भारत सरकार
Government of India
विद्युत मंत्रालय
Ministry of Power
उत्तर क्षेत्रीय विद्युत समिति
Northern Regional Power Committee

Subject: Minutes for 59th Protection Sub-Committee Meeting.

59th Protection Sub-Committee Meeting (23rd April, 2025)-MoM

Minutes of
59th Meeting of Protection Sub-Committee (PSC) of
Northern Regional Power Committee

PMU Plot of Active Power (MW) at APTFL(IP)

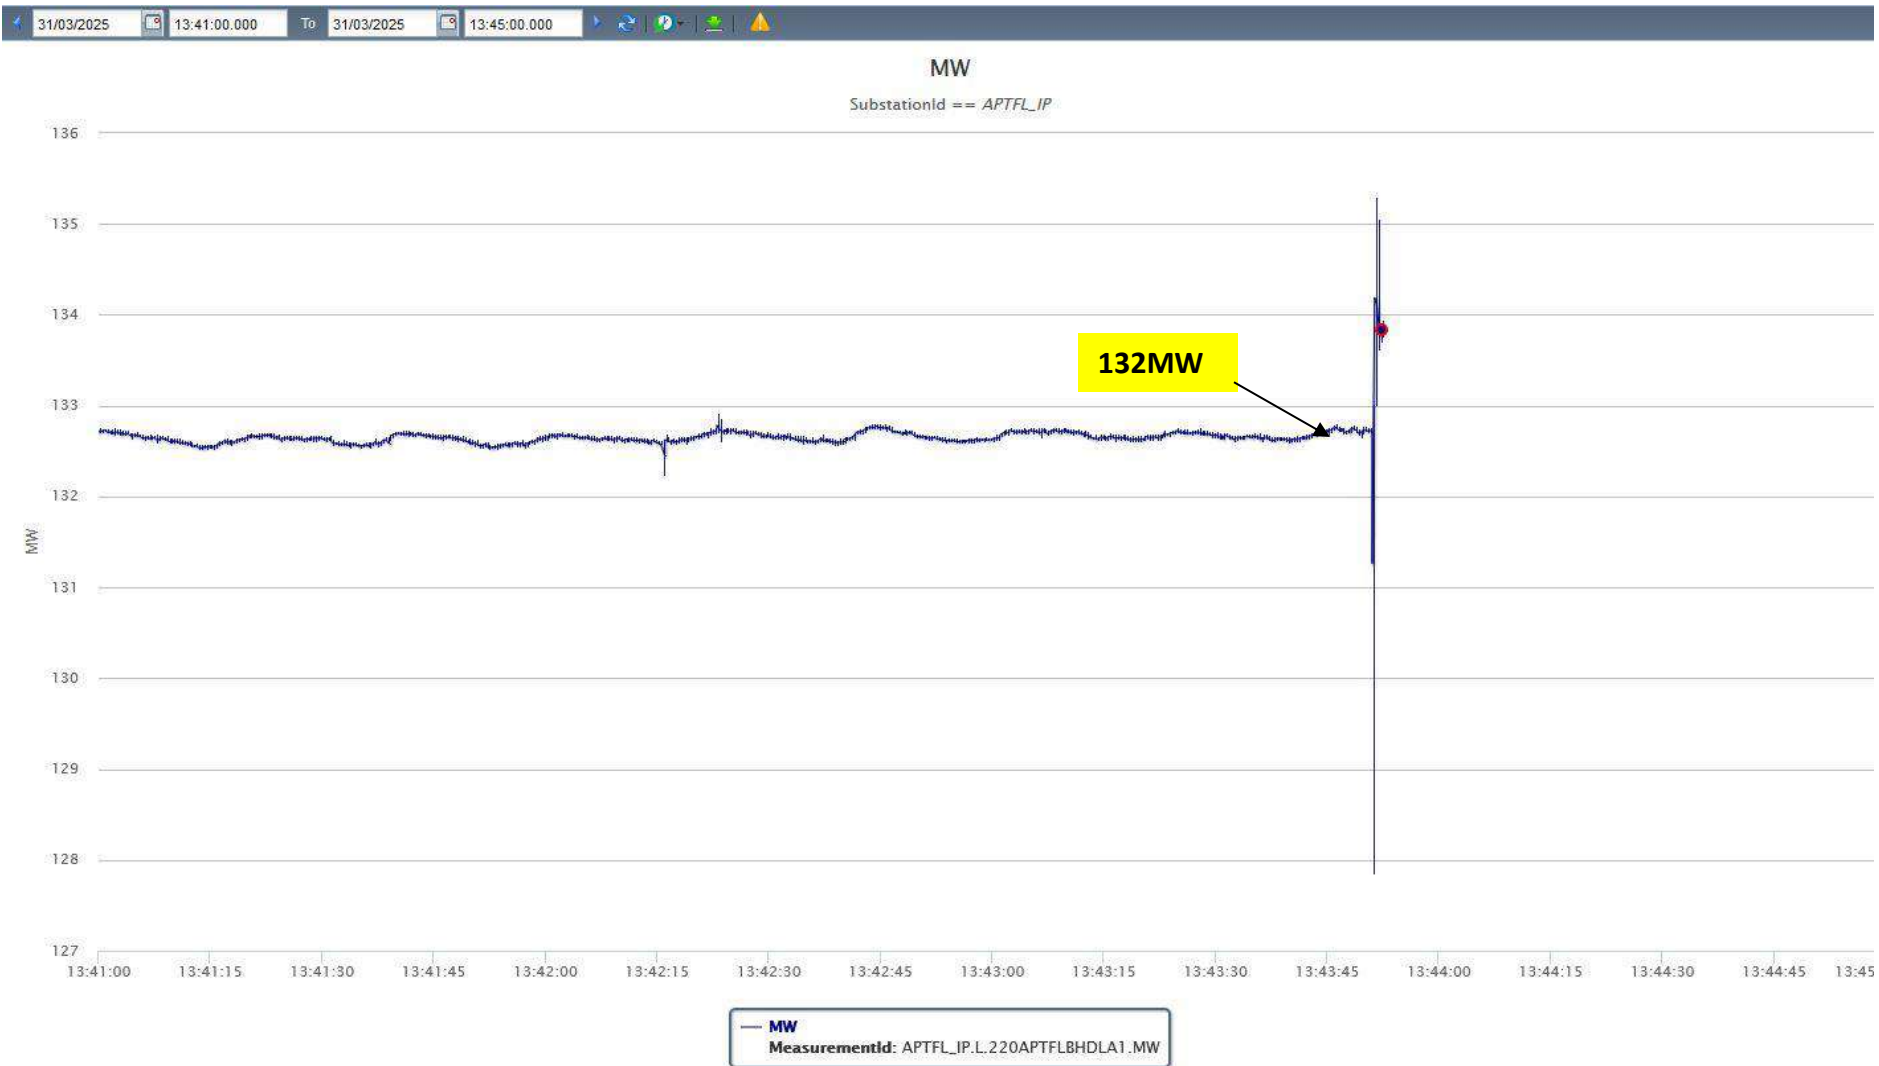
✓ As per PMU, generation loss of approx. 132 MW at APTFL(IP)

PMU Plot of Active Power (MW) at TPREL(IP)

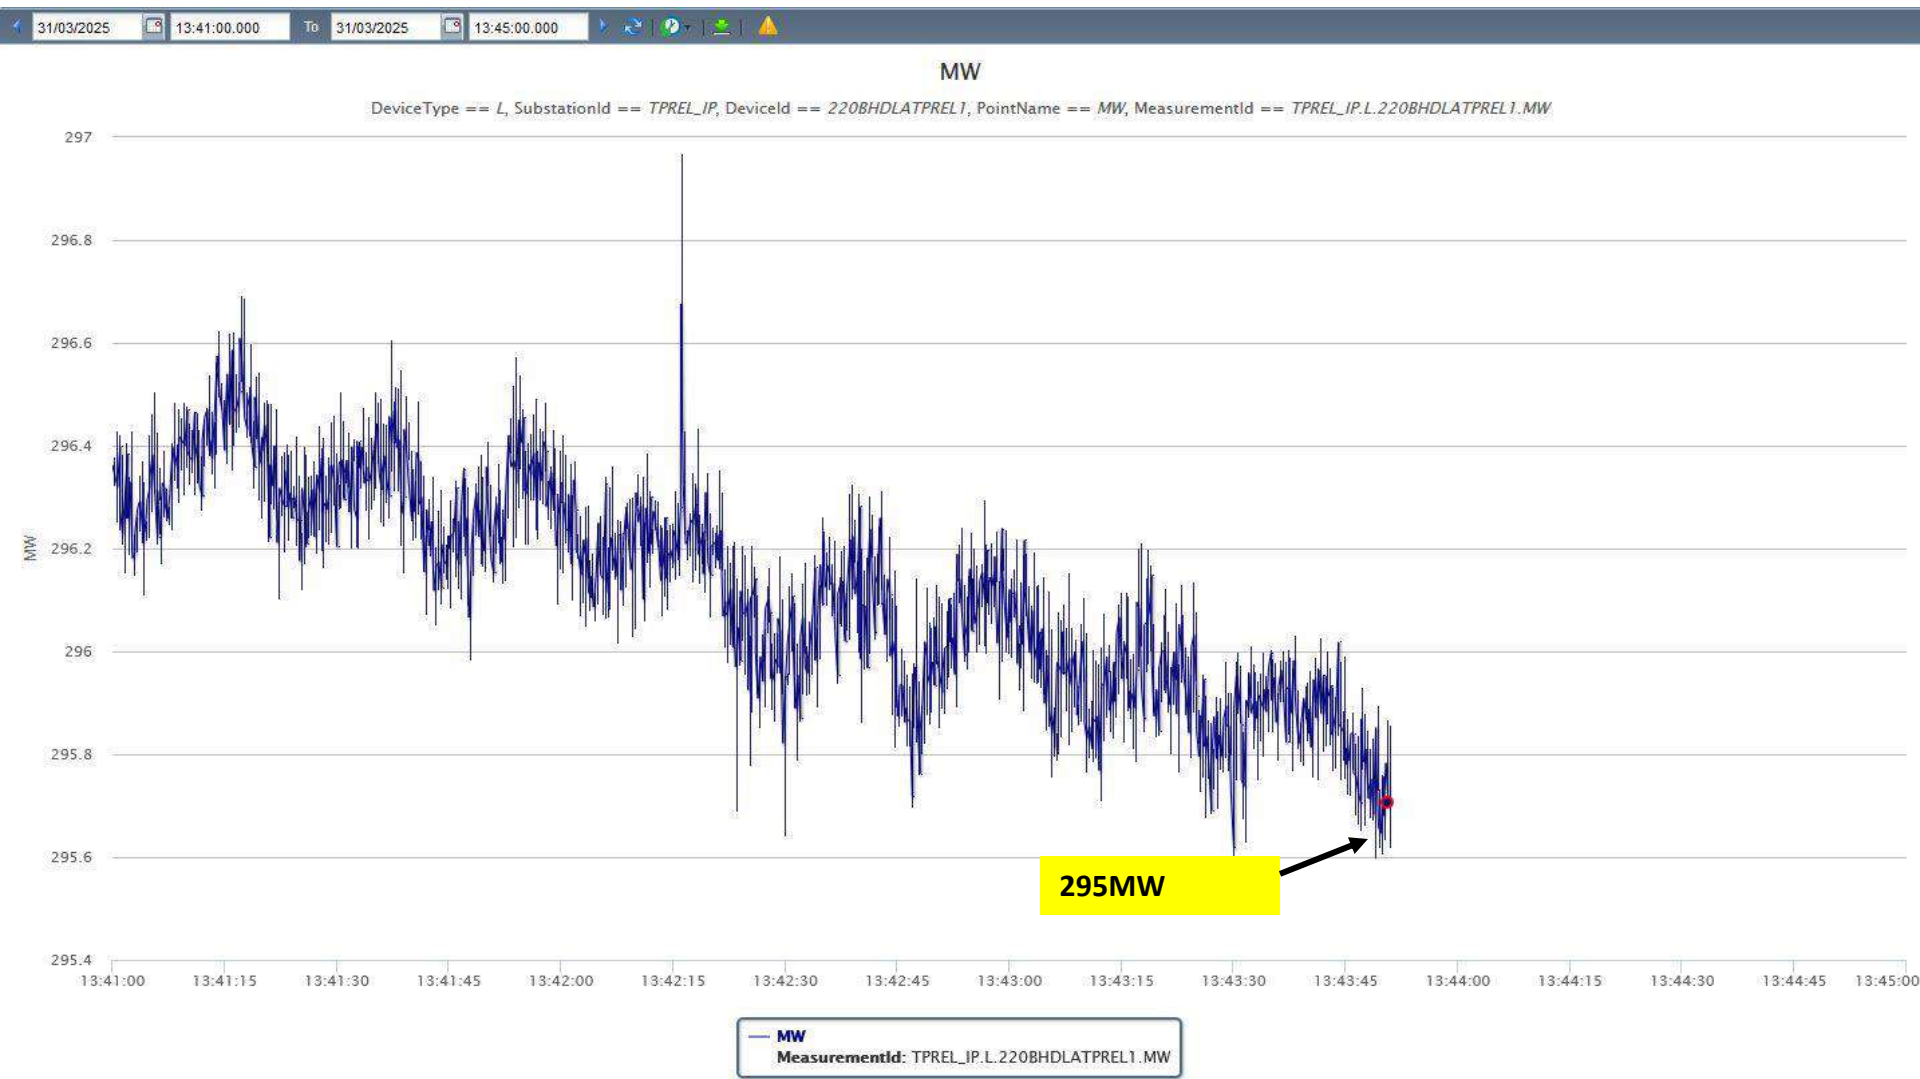
✓ As per PMU, generation loss of approx. 295 MW at TPREL(IP)

DR Of 220kV 220kV Bhadla (end) - Azure Mapple ckt

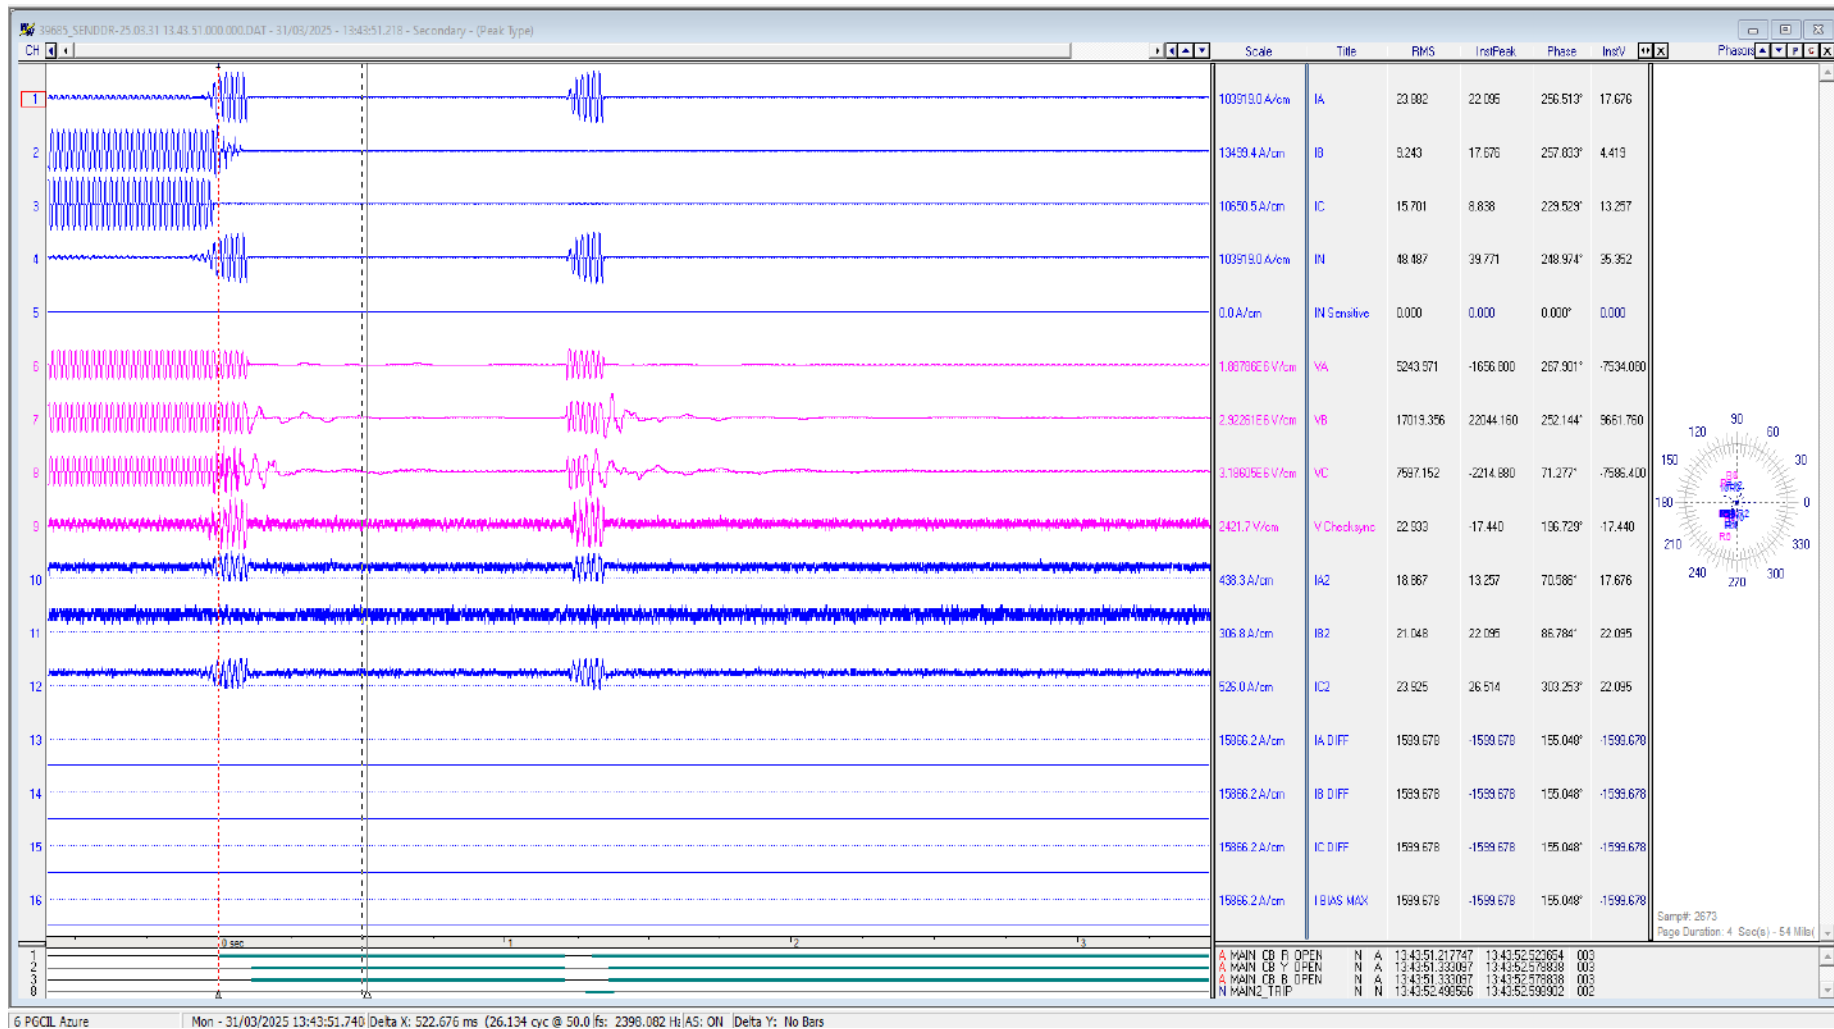
- ✓ R-N phase to earth fault (~7.3kA) with unsuccessful A/R operation is observed.
- ✓ 3-ph A/R is observed.
